Re: Siasconset Beach Preservation Fund (SBPF) 2020 Annual Review (SE48-2824)

On behalf of Mr. Robert Greenhill, I offer several comments on both the SBPF 2020 Annual Review as well as on the Independent review of Mr. Greg Berman. Most of my comments are updates to my earlier letter of March 11, 2021.

Figure 1. Cumulative sand mitigation requirements and placements

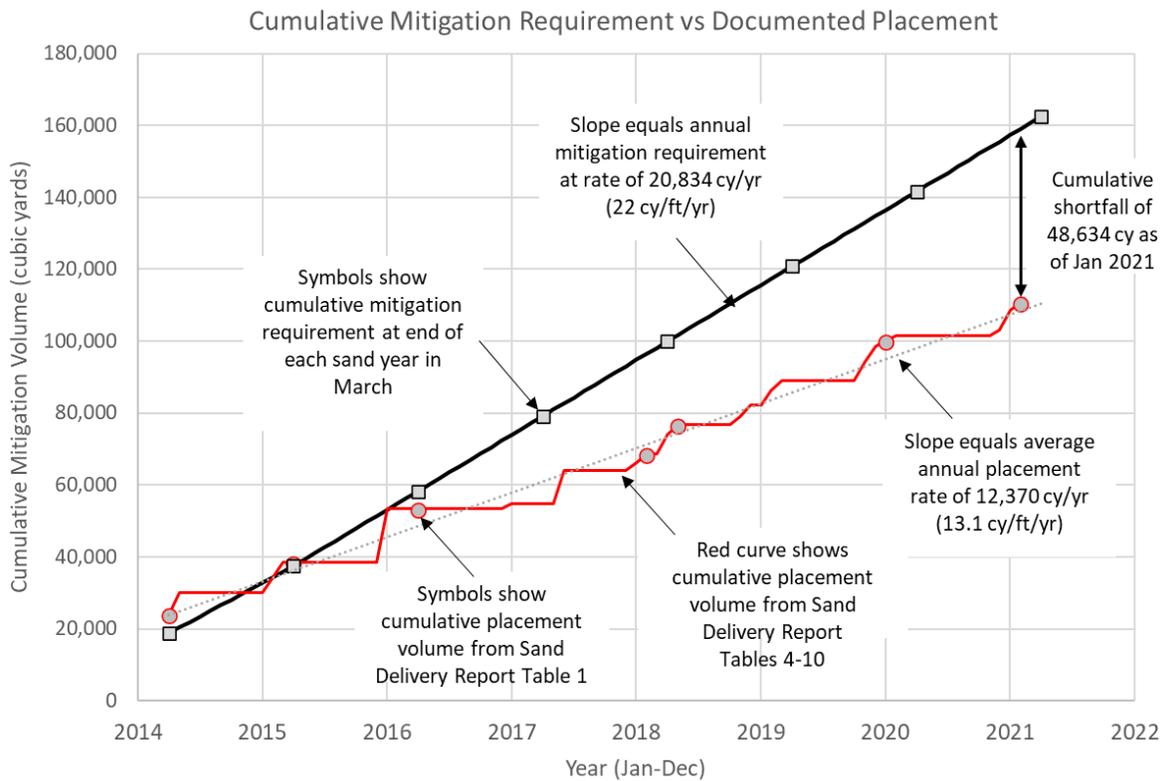
As a result, as shown in Figure 1 and in Table 1, this annual shortfall also means that the cumulative shortfall in mitigation placement has continued to grow. According to my estimate, the total cumulative shortfall in sand mitigation is about 47,405 cy through January 2021.

To arrive at my numbers, the upper black curve in Figure 1 shows the mitigation requirements, accumulated at a rate of 18,744 cy/yr for the first two years, and 20,834 cy/yr since 2015. By the middle of January 2021 (the end date of the 2020 Sand Delivery report but 2.5 months shy of the full sand year ending in March), a total cumulative mitigation volume of 158,152 cy should have been placed<sup>1</sup>.

As of January 2021, my estimate is that the cumulative shortfall, based on the difference of the cumulative requirement minus the cumulative placement, has reached 47,405 cy. As a result, SBPF is now more than two years behind on sand mitigation.

Further, while Mr. Berman concludes that the cumulative shortfall will reach more than 50,000 cy by 2025, I believe that a 50,000 cy shortfall will likely be reached this year, in 2021, unless SBPF substantially increases sand placement rates. For example, by this time next year in March 2022, the cumulative mitigation requirement would increase to 186,326 cy. The “catch up” requirement for SBPF to achieve the required mitigation within the next year is therefore  $186,326 - 110,747 = 72,579$  cy.

Figure 2 Sand template from Tier 4 construction document

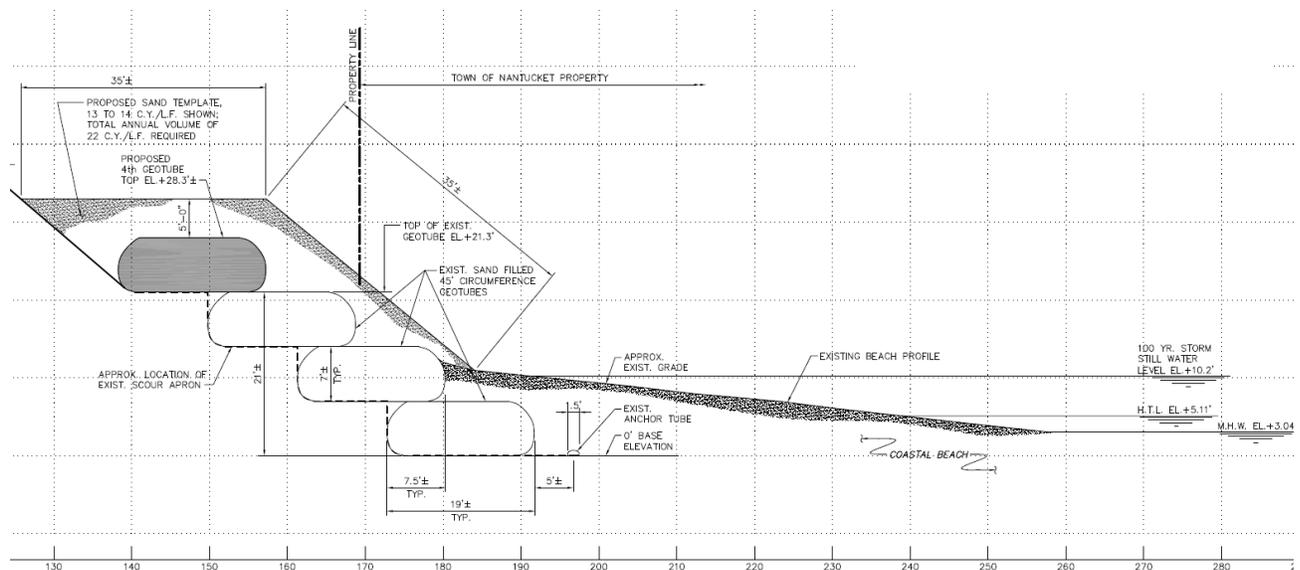
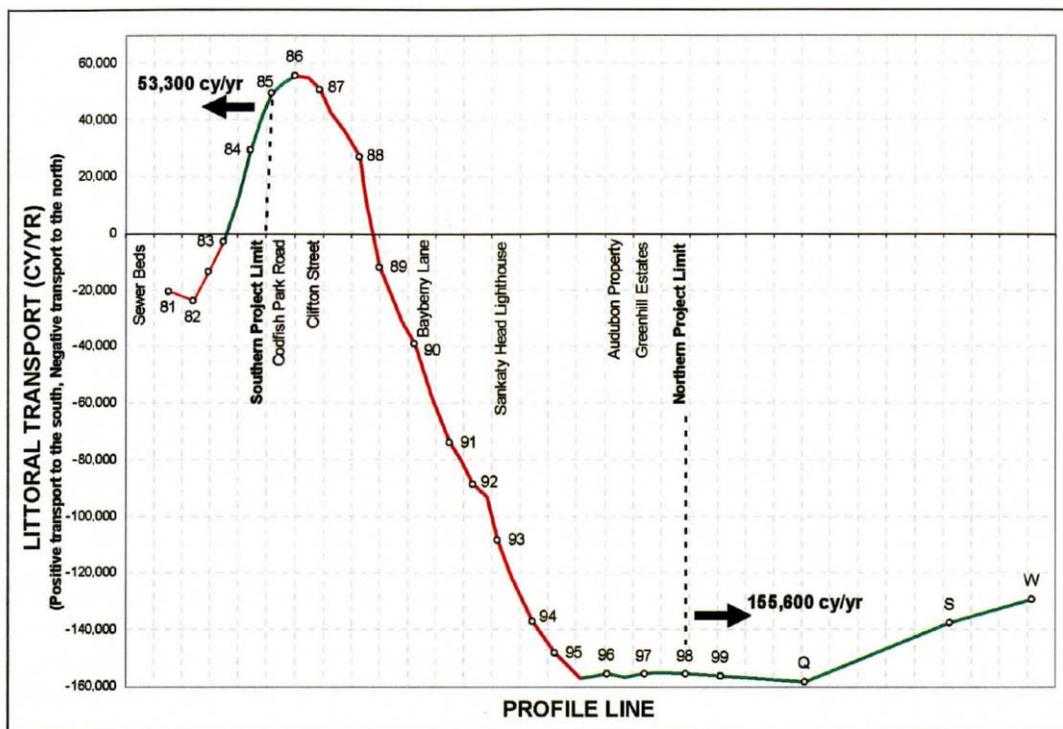
The Annual Report discusses sand volumes (or cross sectional areas) in the “sand template” but how the template is defined is not clear. In the Commission files from the Tier 4 construction, I found a proposed template shown in Figure 2 (note that I cut off the bluff portion to the left to enlarge the portion with the geotubes).

In the future, it would be useful if a detailed drawing of the template appeared in Annual Reports, with beach and template survey data plotted so that it would be clear what the actual in-place template looks like compared to the drawings.

In my opinion, the template also requires clarification with regard to how mitigation sand is placed, and it would be useful to separate out portions of the template that serve different functions. First, in Figure 2, I note that the notation of template volume appears to include the volume of the geotubes themselves. I would suggest that sand in the geotubes is not available to the littoral system and should not be included in any assessment of template volumes. Second, sand used as protective cover for the geotubes should be indicated separately from sand intended primarily as mitigation. Third, the template drawing should indicate how mitigation sand is to be placed.

I fully concur with Mr. Berman that mitigation sand does not need to be placed on the template (as shown in Figure 2) and should be placed both seaward of the geotubes as well as at the ends of the geotube system.

In the cross section, sand placed on top of the geotubes to elevations of 30 ft or more, will not naturally be mobilized by waves and can only enter the active system if pushed over the geotubes artificially. A more effective method of placement for mitigation would be to place sand in front of the geotubes in the form of a berm, at elevations of 10 to 15 ft or so, and then sloping down to MHW. This berm would hold maybe half the mitigation sand and would serve to protect the base of the geotubes while also feeding the littoral system. Additional sand volume could be placed at the ends of the geotube system where it would be more readily available to downdrift beaches.

Note that these recommendations are consistent with the Conservation Commission Additional Conditions specified at the time of the Tier 4 construction, which indicated that mitigation sand should be placed in a berm from the toe of the bank out to MHW and also 300 ft from ends of the geotube installation.
